- DA 2015/046
- CT 139505/1

Re SUBDIVISION

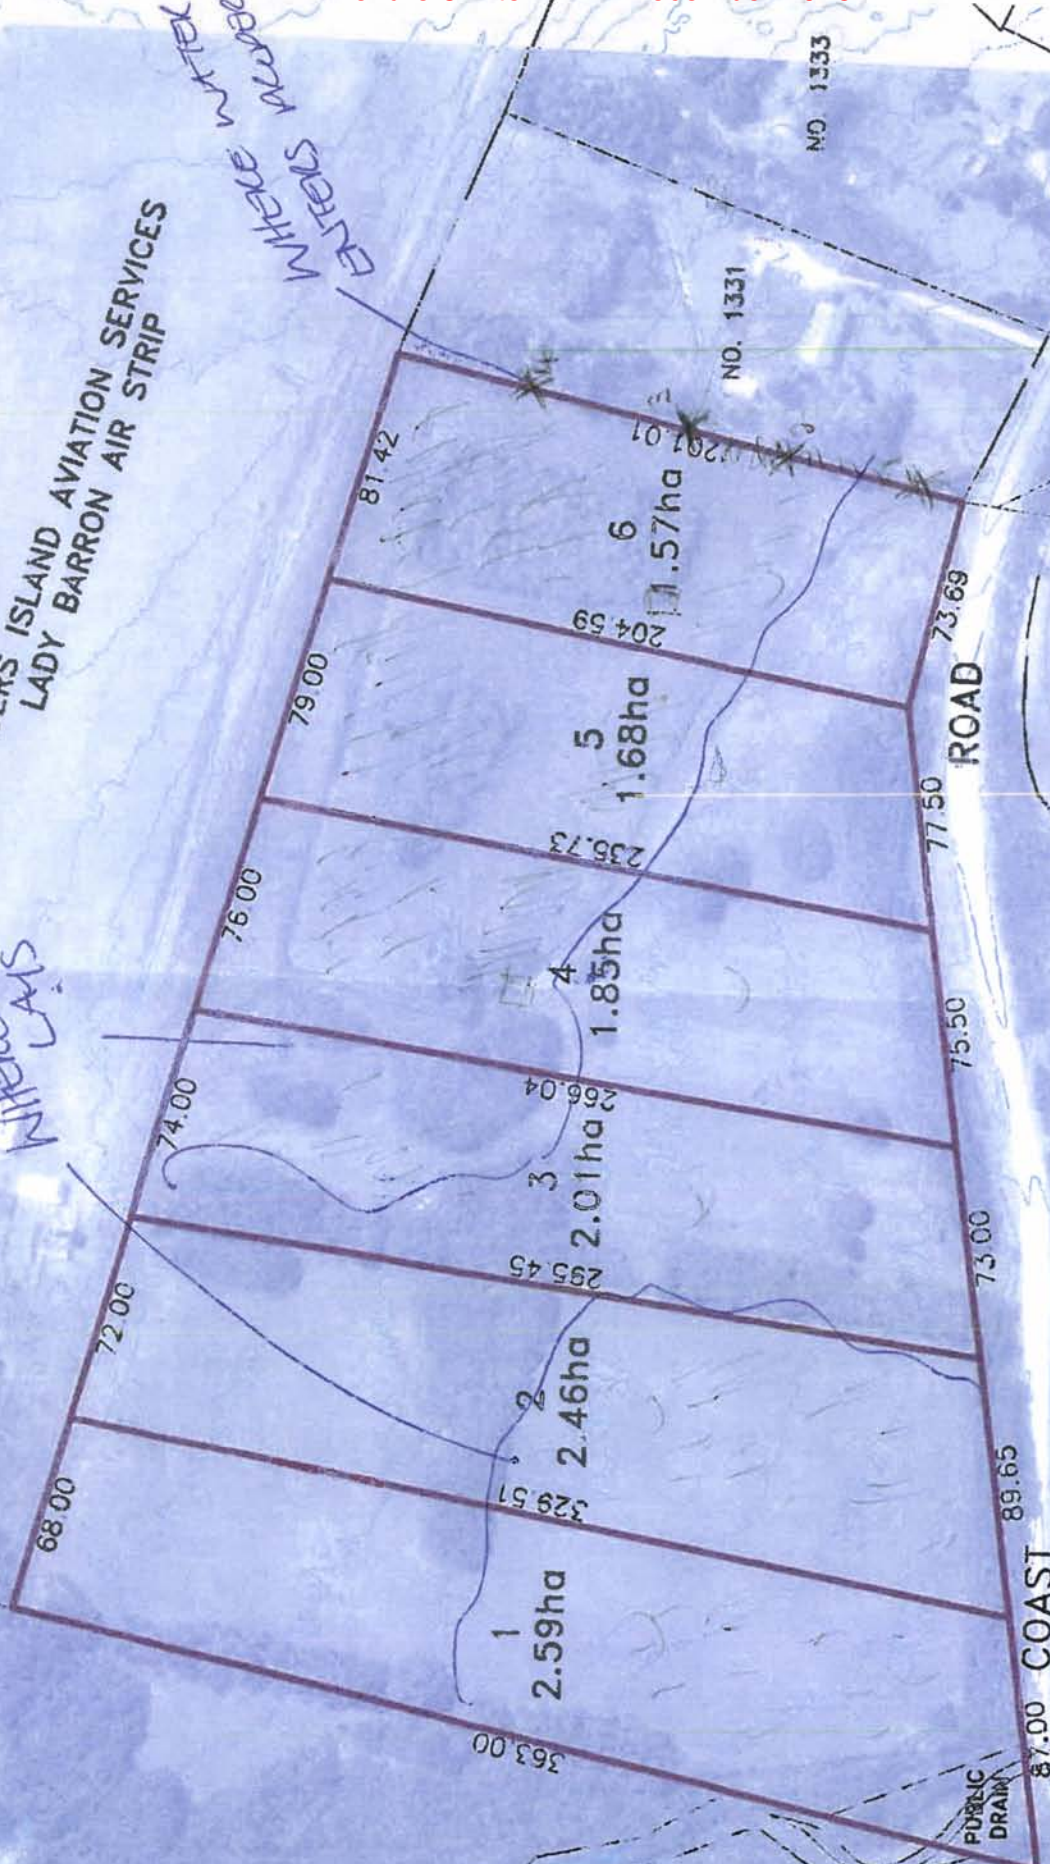
I have no objections to subdivision, but would like to see water that comes into 1331 diverted (drained) so that it doesn't effect my place. In the winter the first year I moved in (approx) six year ago it was very wet. A lot of the water that came in was from cross 3 and made it extremely wet.
